ADDENDUM NO. 2

PROJECT: Morningside Tennis Court Lighting

PROJECT NO. 19-0035-PR

THIS ADDENDUM NO. 2 ISSUED TO CLARIFY SUBSTITUTION OF EPHESUS SPORT LIGHTING FOR MUSCO SPORT LIGHTING TO BIDDING DOCUMENTS FOR MORNINGSIDE TENNIS COURT LIGHTING - PROJECT NO. 19-0035-PR OF THE CONTRACT DOCUMENTS FOR THIS WORK, THIS ADDENDUM CONSTITUTES A PART OF THE CONTRACT DOCUMENTS. ACKNOWLEDGE RECEIPT OF THIS ADDENDUM ON THE PROPOSAL FORM.

MORNINGSIDE ATHLETIC CENTER
TENNIS COURT LIGHTING
40' MOUNTING HEIGHT POLES
30 FOOTCANDLES AVERAGE
SPILL LIGHT AT 100' ADDED

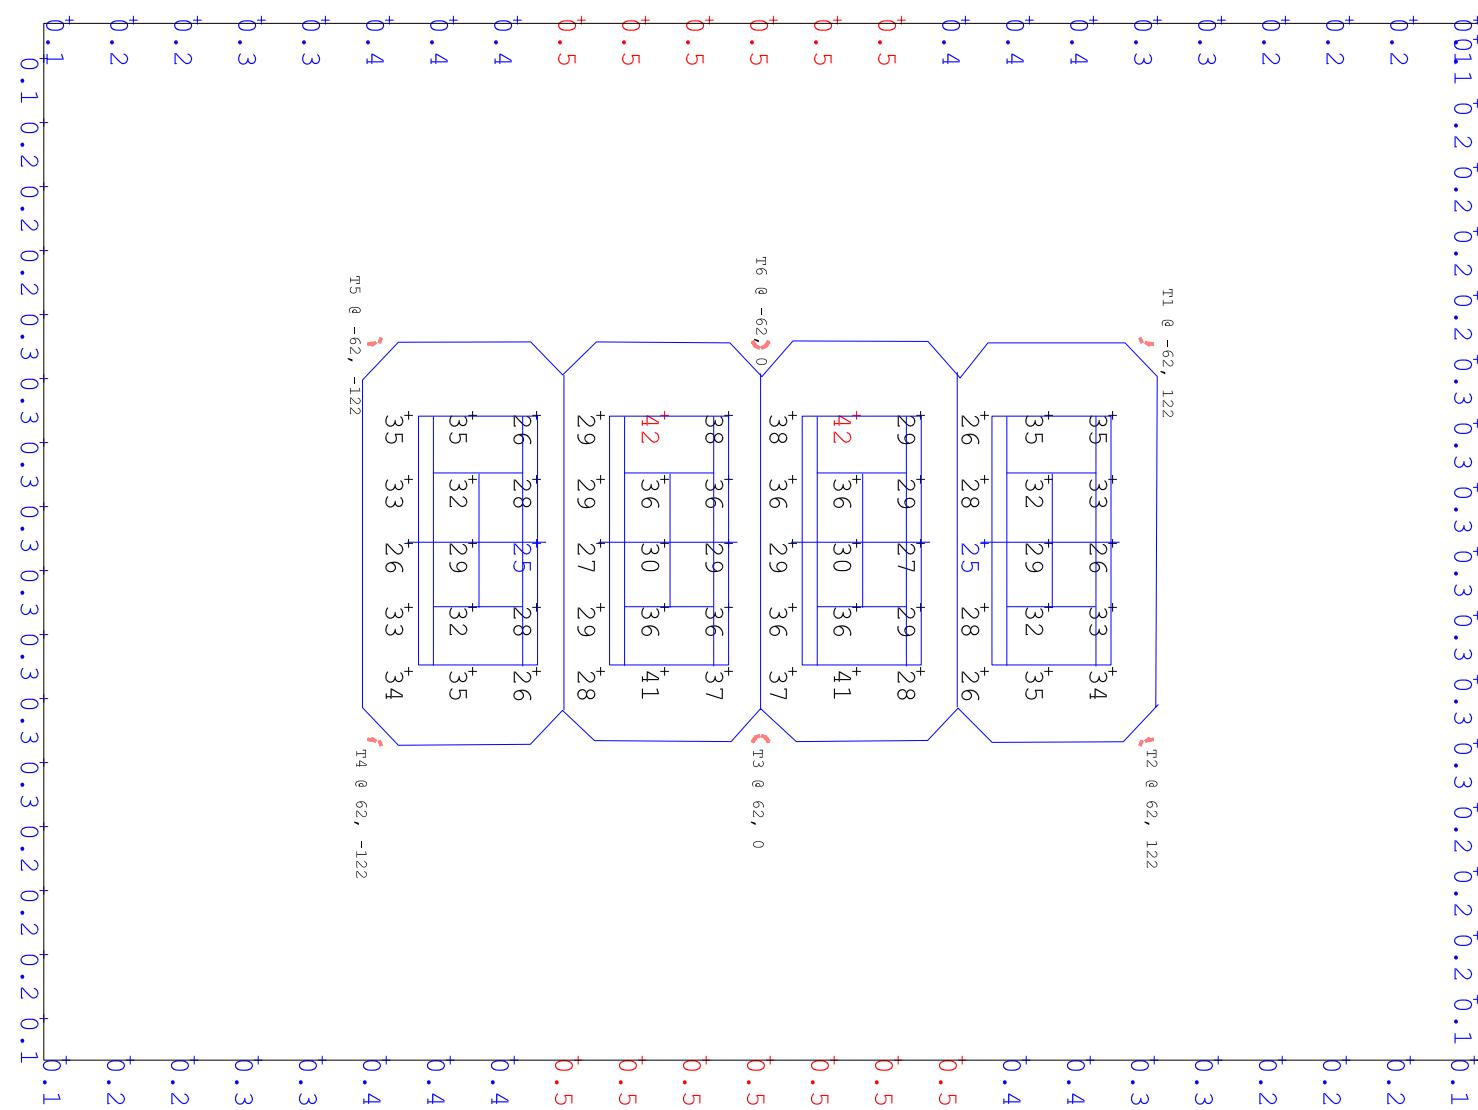
- b. Pole heights are 50'. This is to control the glare on the surrounding properties. The project was designed to protect the neighbors from spill AND glare

- c. Light design required by the City of Clearwater is 30fc minimum grid point. The attached designs are 30fc average with multiple grid points being less than 30fc

MATERIAL SPECIFICATIONS

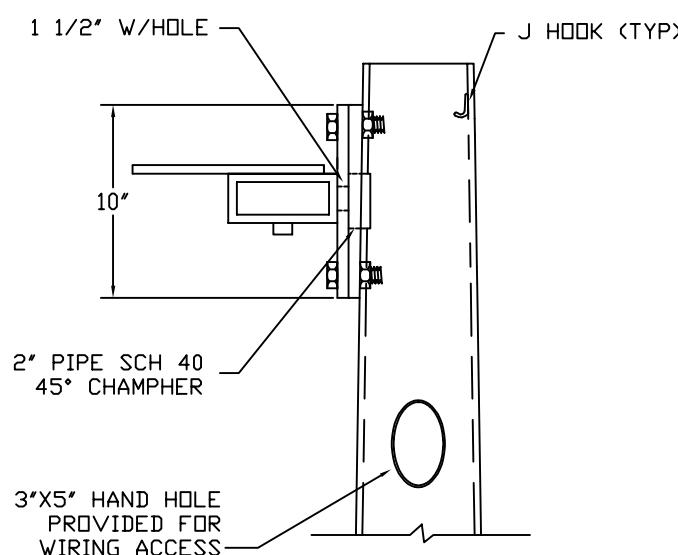
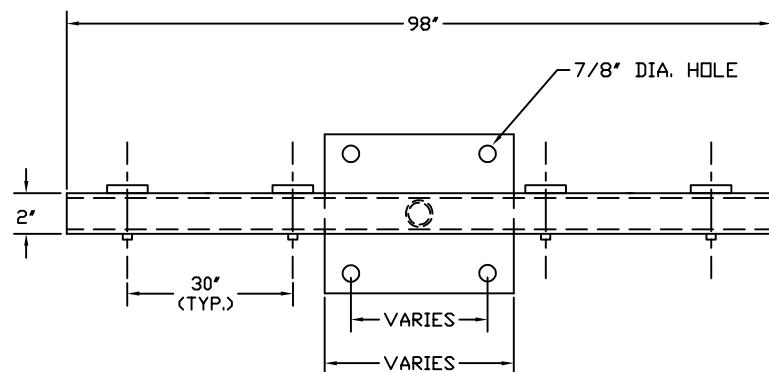
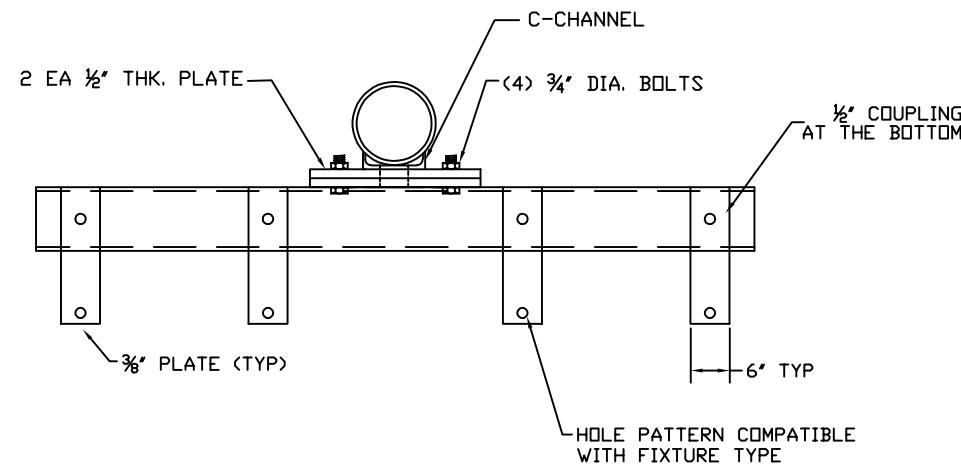
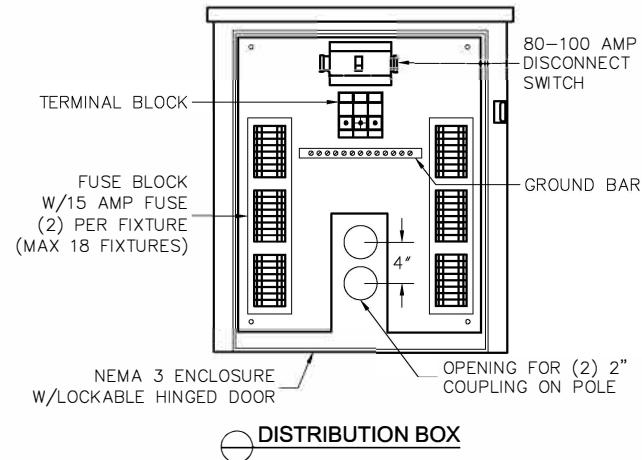
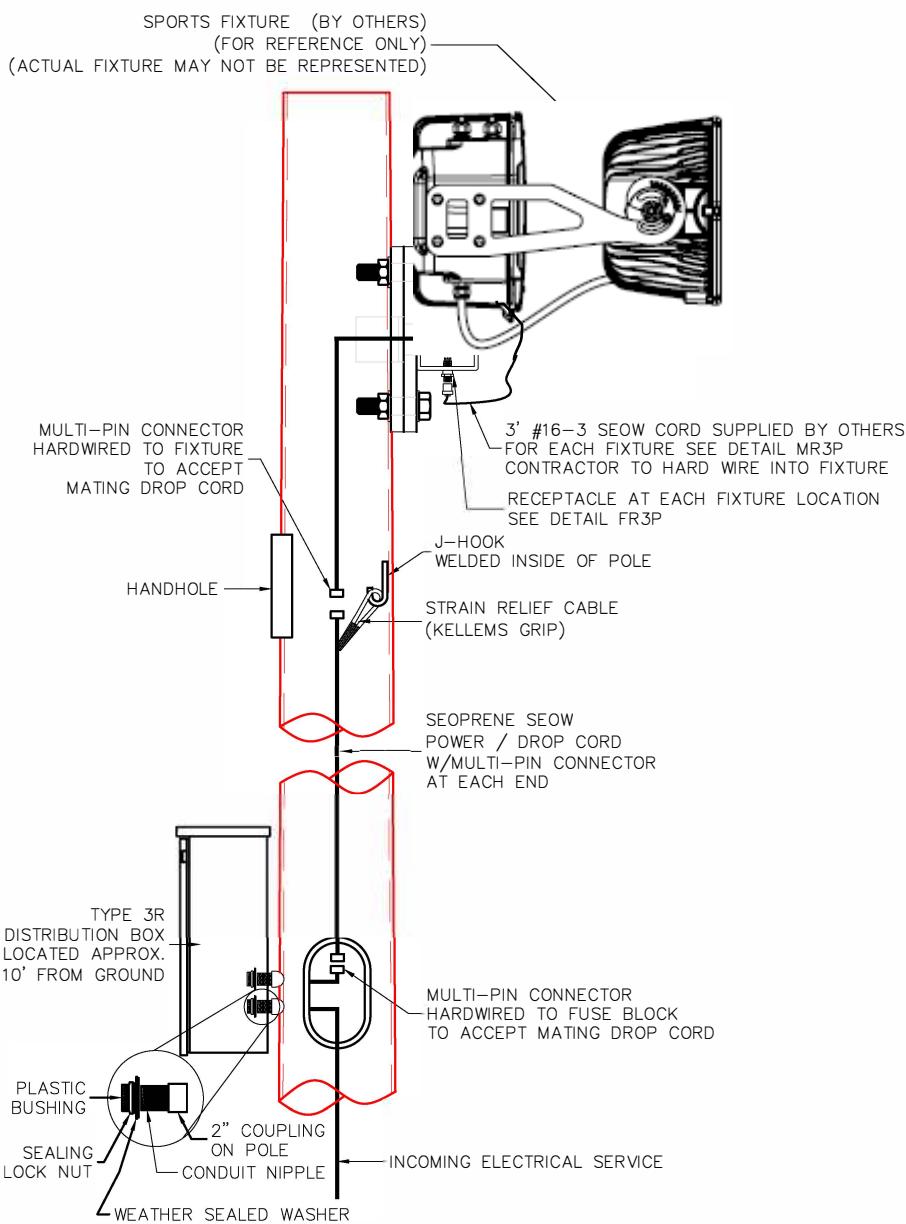
- s. There is no information on the fixtures ability to withstand 150mph winds as specified in 2.1, D – 7
 - t. No information on controls and monitoring as required in the specification

Disconnect Box

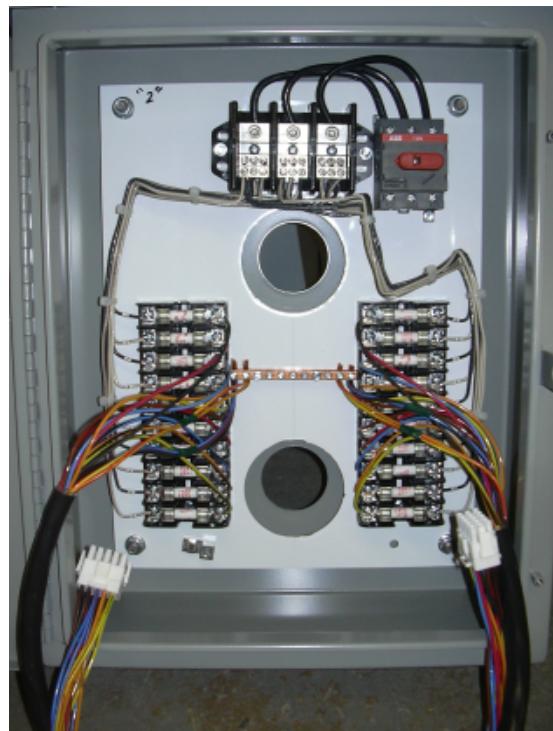
- u. SO cords are used to power the fixtures. Internal wiring is specified.
